**CERTIFICATE OF APPROPRIATENESS****Application Date:** July 3, 2017**Applicant:** Mark Van Doren, APD Design for Kellie Elder, owner**Property:** 1248 Harvard Street, W 76.25' of Lot 24 & Lot 23B, Block 188, Houston Heights Subdivision. The property includes a 3,138 square foot, two-story wood frame single-family residence and 440 square foot attached garage on a 5,537 square foot corner lot.**Significance:** Noncontributing new single family residence, constructed circa 1999, located in the Houston Heights Historic District East.**Proposal:** Alteration – Addition *Resubmittal*

**Public Comment:** No comment received.**Civic Association:** No comment received.**Recommendation:** Denial - does not satisfy criteria 3a or 3b: The overall width of the house and height of the addition are not typical dimension found within the context area.**HAHC Action:** -

**NORTH SIDE ELEVATION**

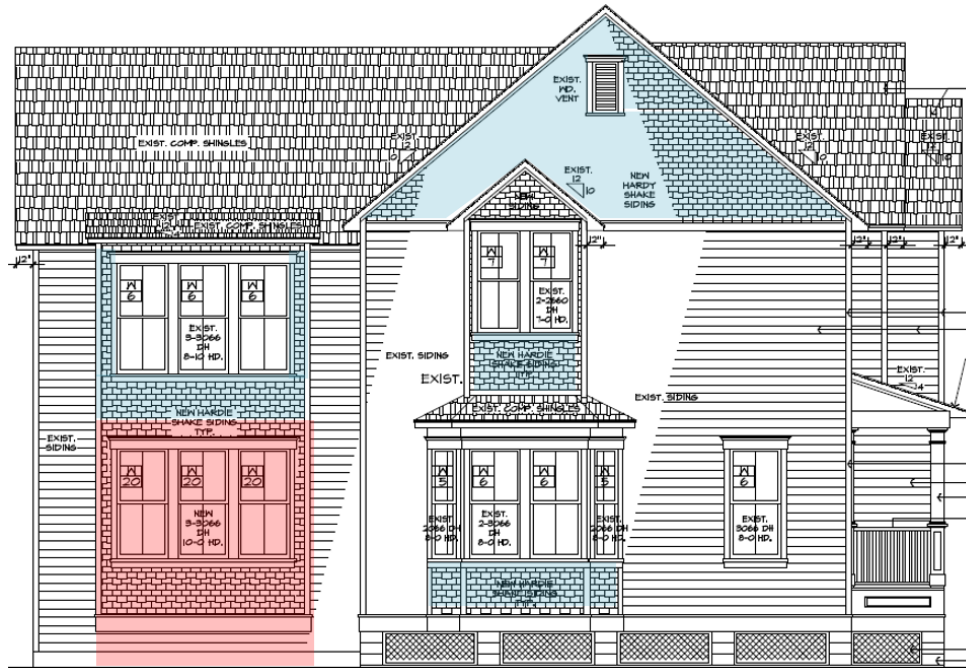
- While the majority of the proposed addition will be located behind the 30' build line, a 2'-4" extension of the front wall will be constructed in front of this line. Previously, staff noted at past meetings that no portion of the addition should encroach the halfway point on the lot, which is at 34.5'. It has also been noted that any additional width is incompatible with the surrounding context area. It is unlikely that any substantial addition would ever be compatible. However, any potential addition should be located as far back as possible and be as low as possible as to minimize the overall impact of the mass.*

- The proposed addition is not compatible since the existing house is already out of scale with other houses in the context area and adding additional width and height creates an even more out of scale structure. The forward location of the proposed attached garage addition along with the added width creates a mass that is not compatible with the typical proportions and scale of existing contributing structures in the context area.*
